SUBJECT: EPC Z-81-97-1, VILLA FALOMAR DEVELOPMENT

RE: CONCEPTUAL GRADING AND DRAINAGE PLAN FOR THE VILLA PALOMAR DEVELOPMENT

RE: CONCEPTUAL GRADING AND DRAINAGE PLAN FOR VILLA PALOMAR

RE: DRB-83-69 VILLA PALOMAR

Phase I

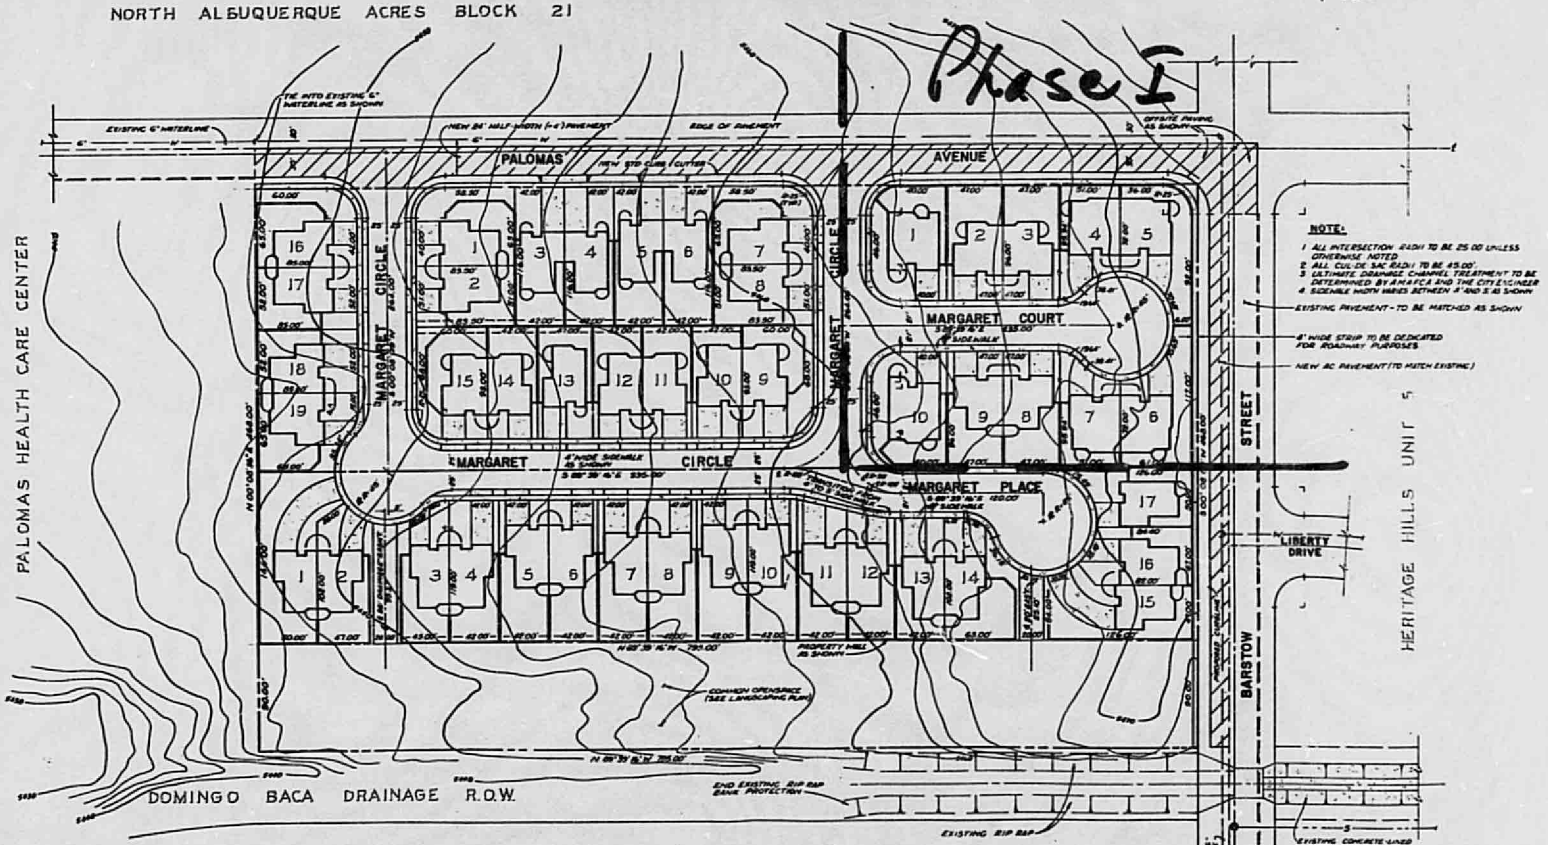
Per our discussion at DRB this morning, this office is requiring that a revised Grading and Drainage Plan be prepared for the Phase 1 site. An assessment of your statement that "each phase can stand alone" will only be made after a review of the plan. Criteria and regulations outlined in the Drainage Ordinance and Development Process Manual should be followed for planning purposes.

1. Ordinance does not allow on-site ponding

2. Interests of Amafca
